STATE OF WASHINGTON  
DEPARTMENT OF ECOLOGY

**Re: Further Action at the following Site:**

- **Site Name:** JH Kelly LLC
- **Site Address:** 821 3rd Ave Longview, WA 98632 Cowlitz Co.
- **Facility/Site No.:** 74552527
- **VCP Project No.:** SW1529

**Issue Presented and Opinion**

FIGURE 3  
 11/13/91  
 SAMPLE LOCATIONS

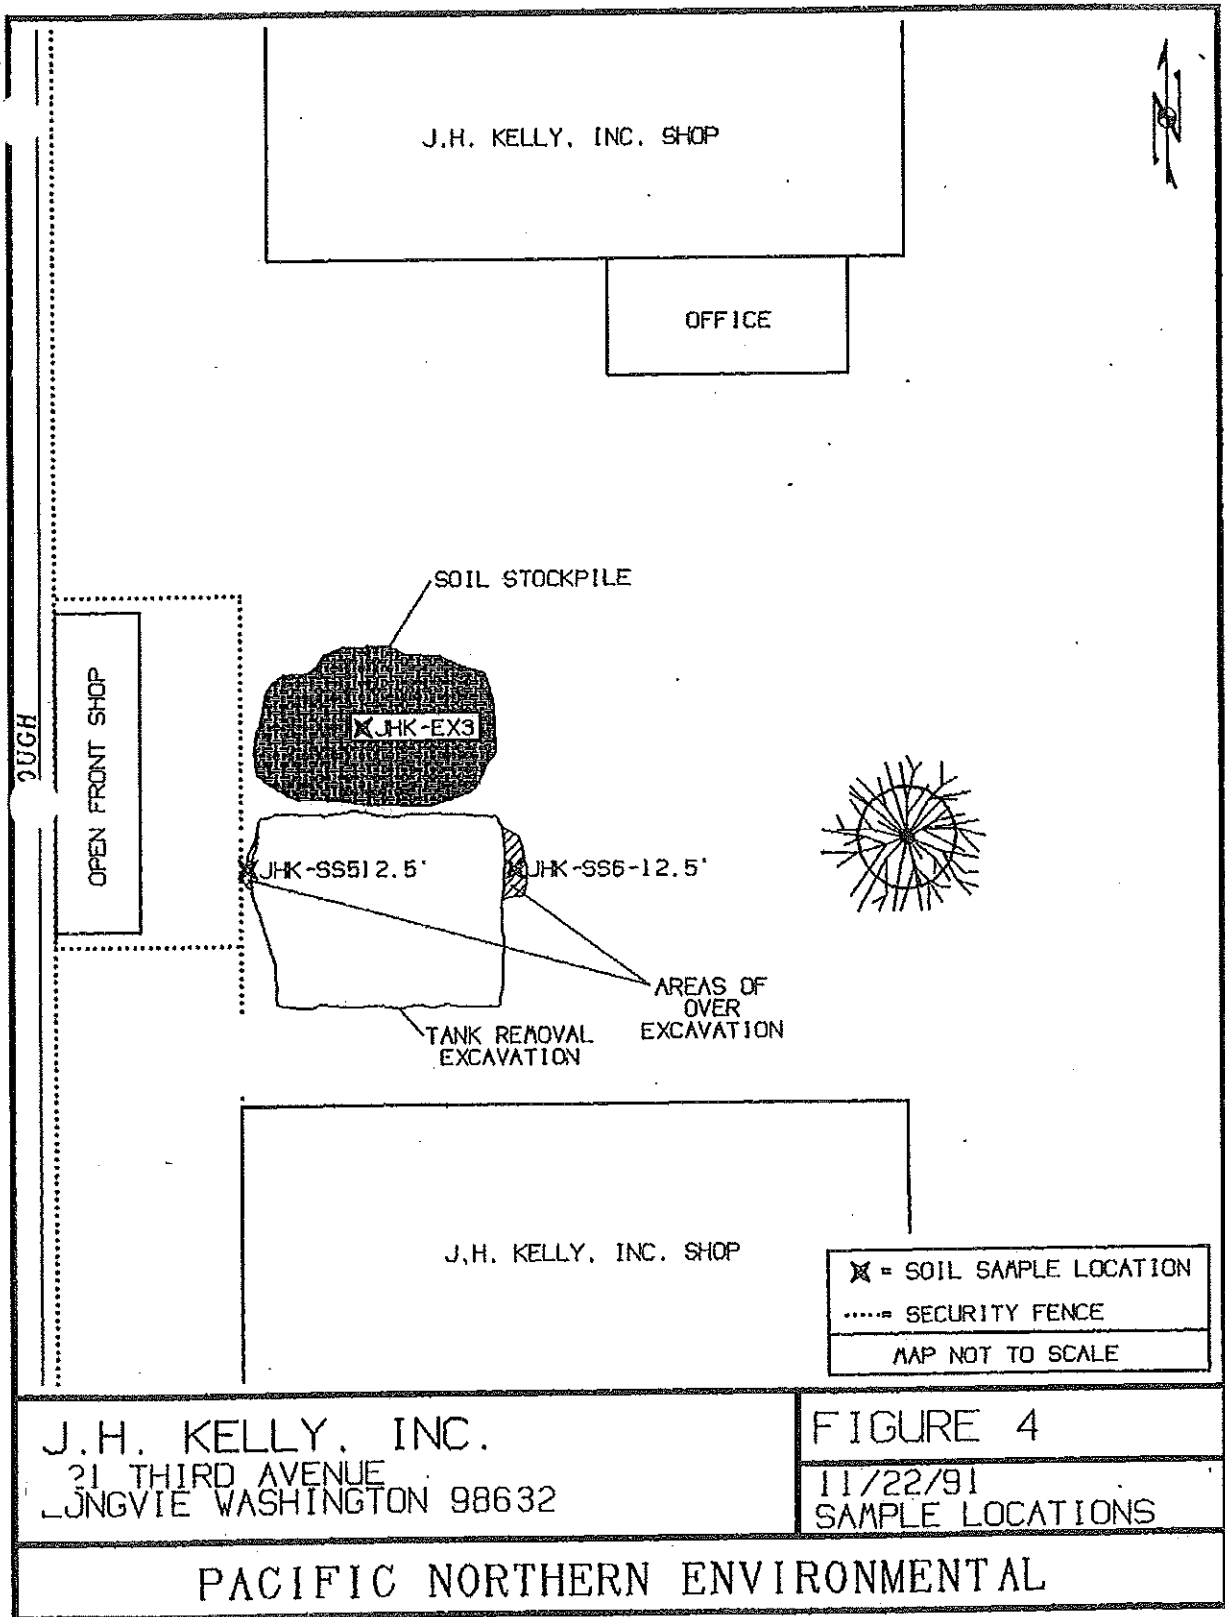
- PNE removed the underground storage tanks and sampled for TPH and BTEX in soil samples taken at 12.5 feet bgs. It is not clear if these samples are from the floor of the excavation or the walls of the excavation (Figure 3).
- PNE did not take any soil samples from the floor of the excavation near the center of the pit, or below the USTs to determine the vertical limits of contamination.
- Two areas were over excavated after initial soil sampling showed exceedances of the 1991 MTCA Method A CULs for soil (Figure 4).
- Although the excavation removed the horizontal extents of PCS in exceedance of 1991 MTCA Method A CULs, there is potentially still benzene present in soil that exceeds the current MTCA Method A CULs (Table 1).
